**RE: Rio Grande Dermatology  
4505 Alameda Blvd. NE  
Permanent Certificate of Occupancy – ACCEPTED  
Engineer’s Certification Date: 12/17/2025  
Engineer’s Stamp Date: 08/27/2024  
Hydrology File: C17D002A33  
Case # HYDR-2025-00449**

Based on the Engineer’s Grading and Drainage Certification received 12/22/2025 and site visit on 12/22/2025, this letter serves as an approval from the Hydrology Section of the Engineer’s Certification for a Permanent Certificate of Occupancy for the Rio Grande Dermatology Building located at 4505 Alameda Blvd NE to be issued by the Building and Safety Division.

SHEET TITLE  
**CIVIL GRADING & DRAINAGE PLAN**

SHEET NUMBER  
**CG-101**

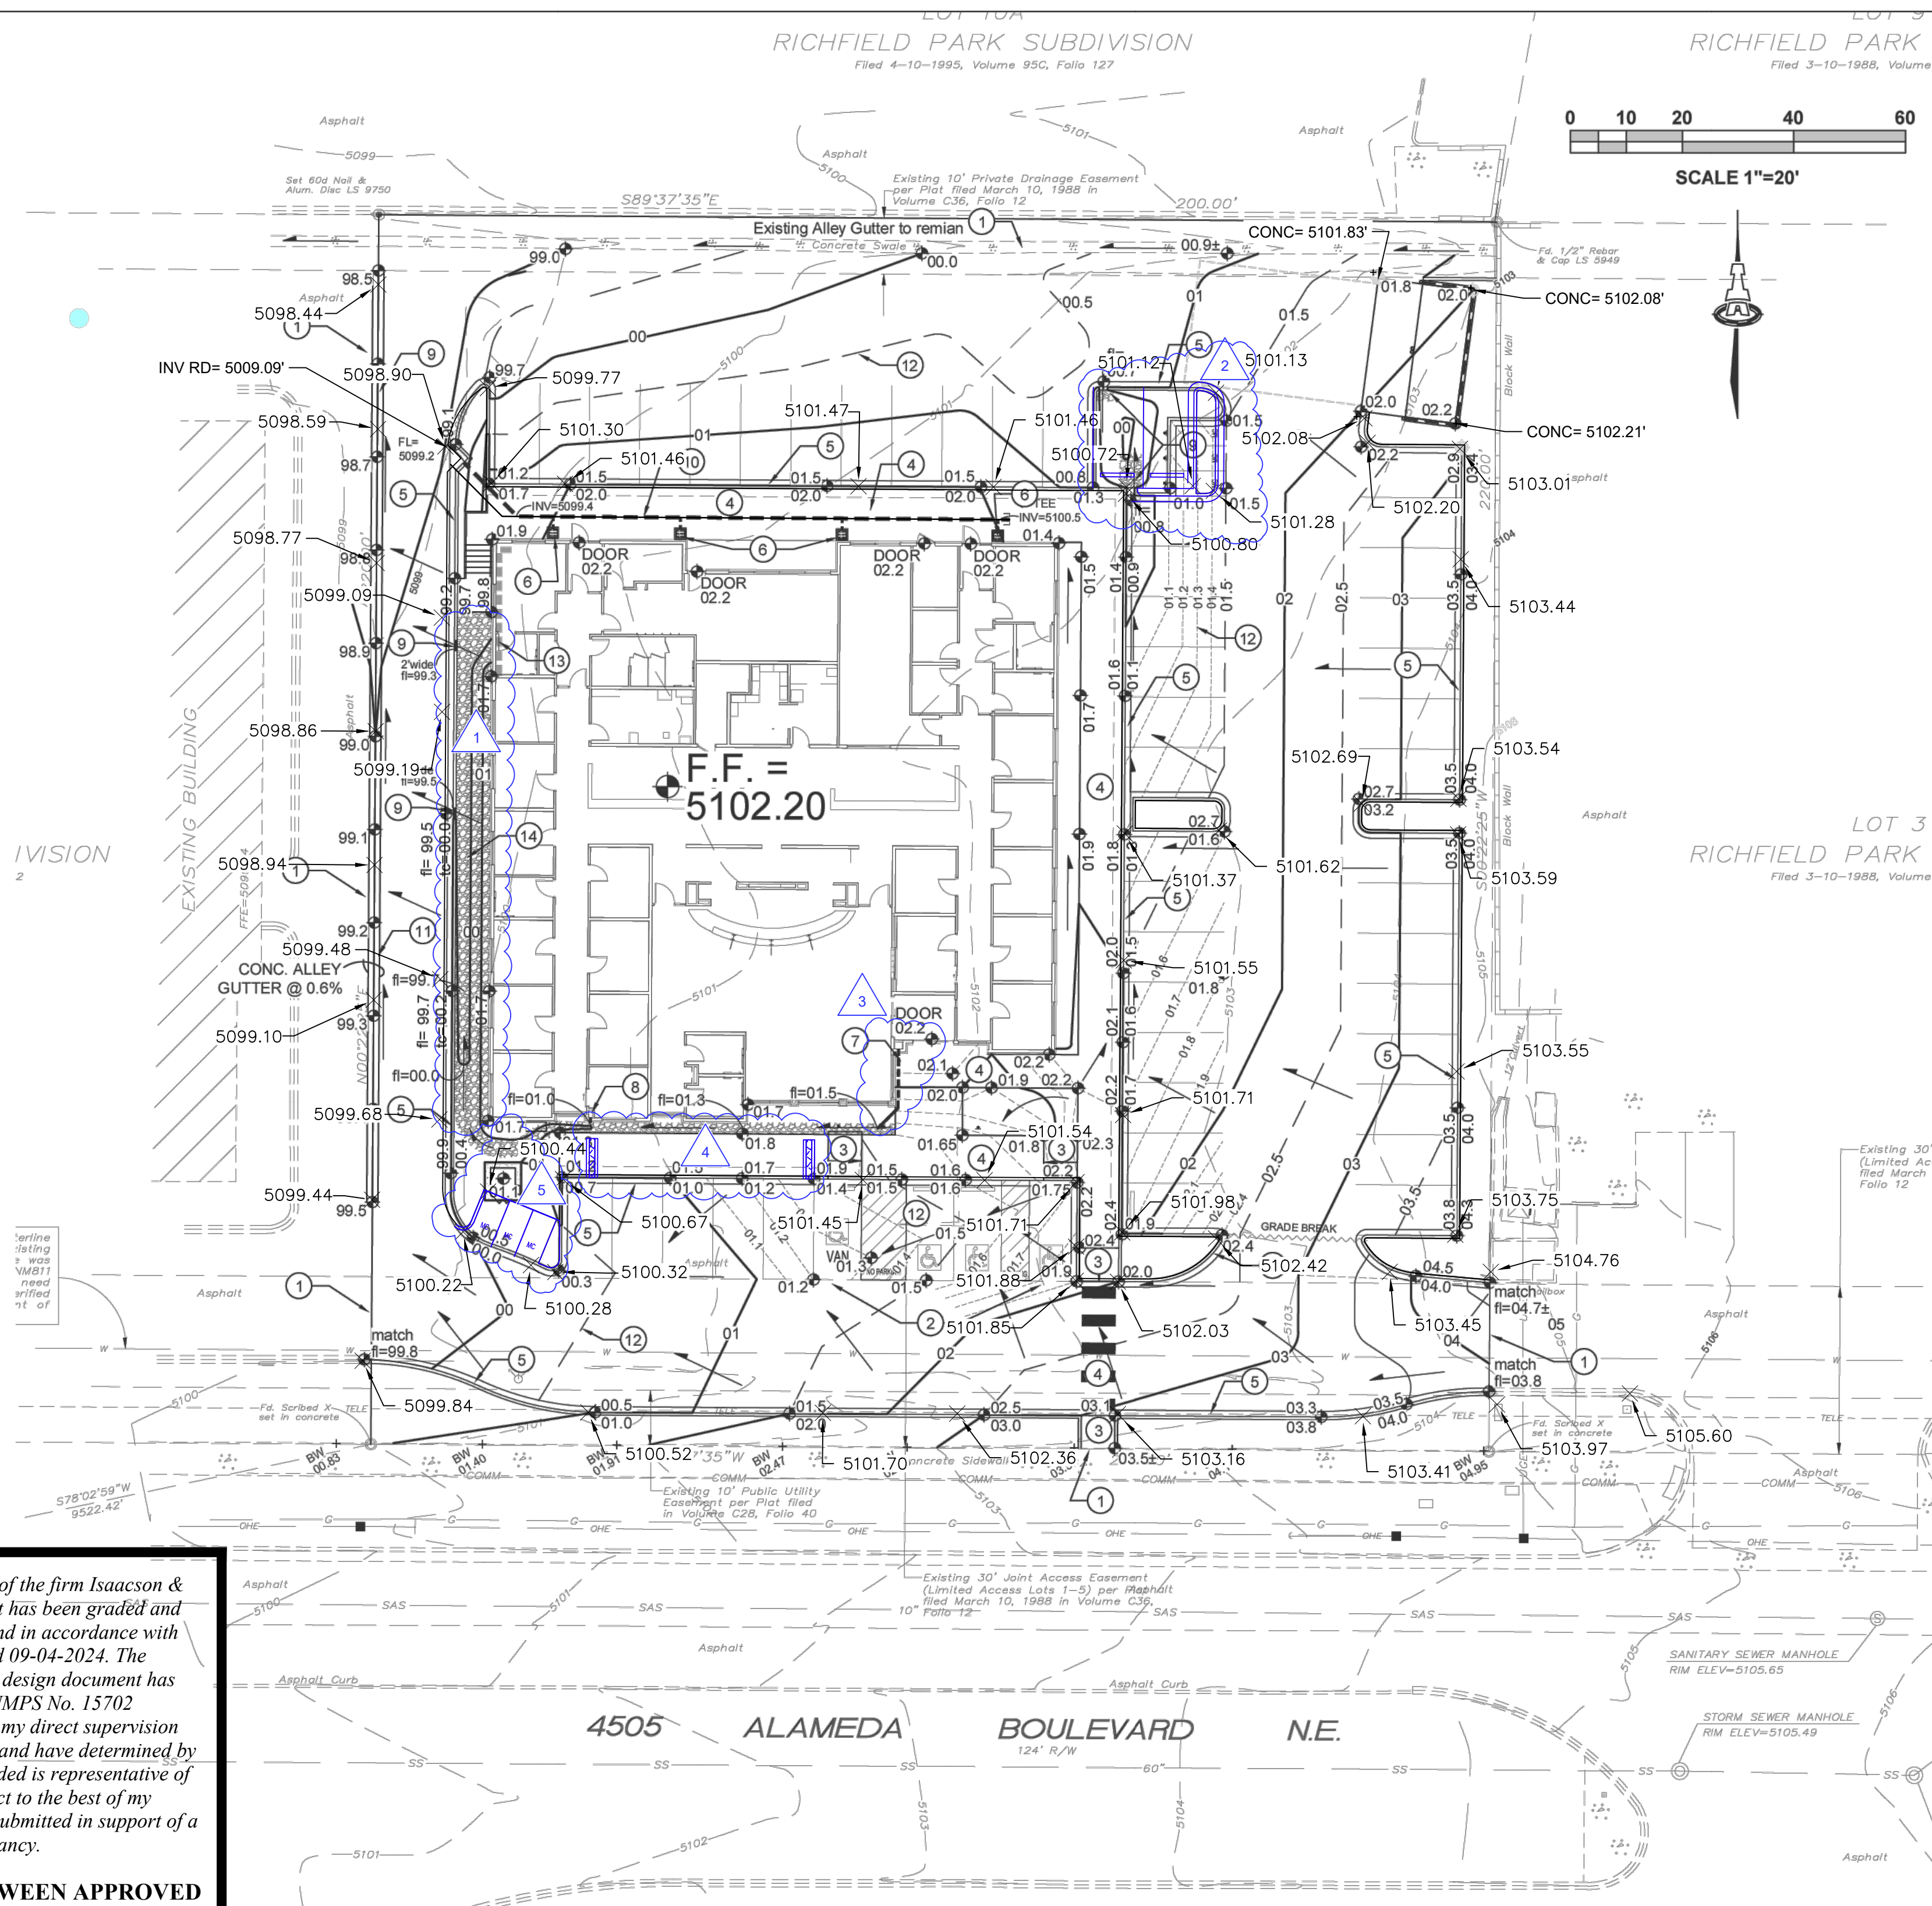
**AREAS OF MODIFICATION BETWEEN APPROVED DRAINAGE GRADING PLAN AND ACTUAL AS-BUILT**

1. SWALE REMOVED AND REPLACED WITH ROCK ARMORING
2. PROPOSED MOTORCYCLE PARKING MOVED, REPLACED WITH TWO ADDITIONAL PARKING SPACES
3. ROOF DRAIN ELIMINATED
4. SIDEWALK CULVERTS ADDED TO DRAIN RUNOFF
5. NEW MOTORCYCLE PARKING LOCATION
